BID BULLETIN for Project No. PEZA MEZ 2023-009

Notice is hereby given to all prospective bidders for the project, **Supply, Delivery and Installation of Air Conditioning Units at MEZ Ground Floor Receiving Area (Re-bidding):**

That attached Lay-out Plan, Revised Technical Specifications and Clarifications on Questions raised during the Pre-bid Conference be part of the PBD.

PP-Aircon Hallway

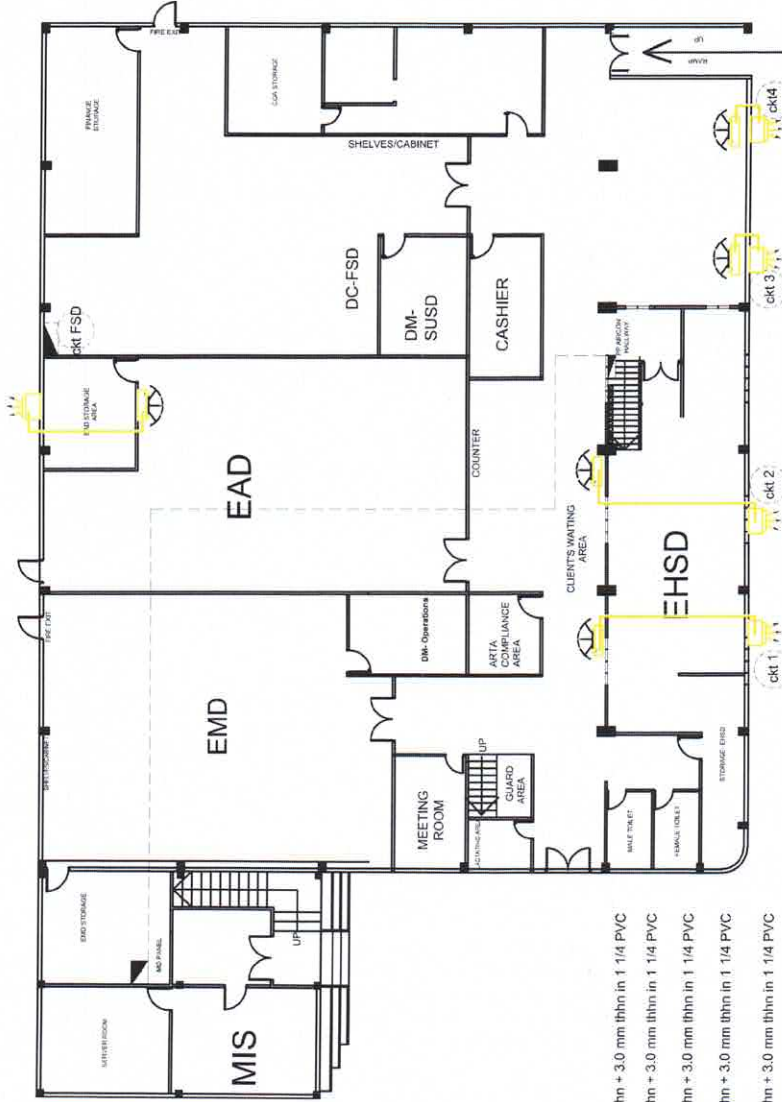
Clarifications on Questions raised during the Pre Bid Conference on 27 October 2023:		
Questions	Answer	
1. Is there a need of Electrical Engineer for wire sizing?	PEZA Electrical Engr provided the sizing computation of wires. See electrical layout plan.

WIRE SIZE FROM MAIN PANEL: MDP TP PP-AIRCON HALLWAY PANEL, 60MM² THHN STRANDED WIRE TO BE USED.

$I_w = (3p + I_h \times 0.25) / F$ $I_{cb} = (3p + I_h \times 2.0) / 0.8$

$= (62 + 31 \times 0.25) / 0.80$ $= (55.8 + 31 \times 2.0) / 0.8$

$= 55.8 \text{ amps}$ $= 94.24 \text{ amps}$

Use: 3 - 80 mm² THHN + 8.0 THHN GND Use: 150 AT 220V-3ph 60 Hz

NOTE: 4 HP AC (EAD) connect to near FSD Panel Board ACU provided ckt FSD
